Service bulletin Nr. 1
Dated Feb. 2, 1999SHEET
1 OF 3Equip. RGT-102
P/N 907-1102-XXX

The purpose of this modification is to improve operation of the control panel during abnormally low DC input bus voltage.

A1 ASSEMBLY

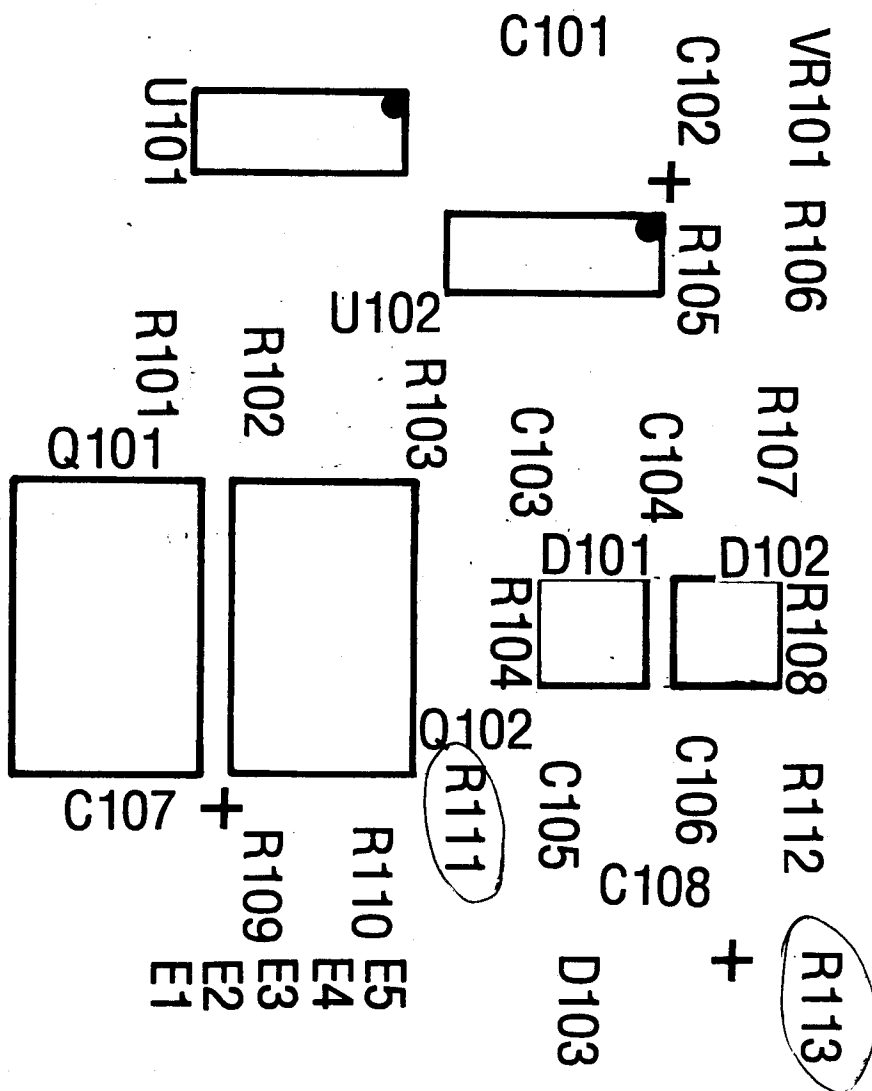
- 2.1 Remove 4 bottom cover retaining screws and lift the cover Free. Save the cover and the screws.
- 2.2 Identify resistors R111 and R113 on the A1 assembly..
- 2.3 Remove resistors R111 (1 megohm) and R113 (2000 ohms) Discard both resistors.
- 2.4 Clean solder from R111 and R113 mounting pads.
- 2.5 Install new value resistors R111 (82K ohm) and R113 (180 ohm)
- 2.6 Clean any solder flux and residue from affected area.
- 2.7 Coat cleaned area with a light coating of urethane.
- 2.8 Install bottom cover and 4 retaining screws.
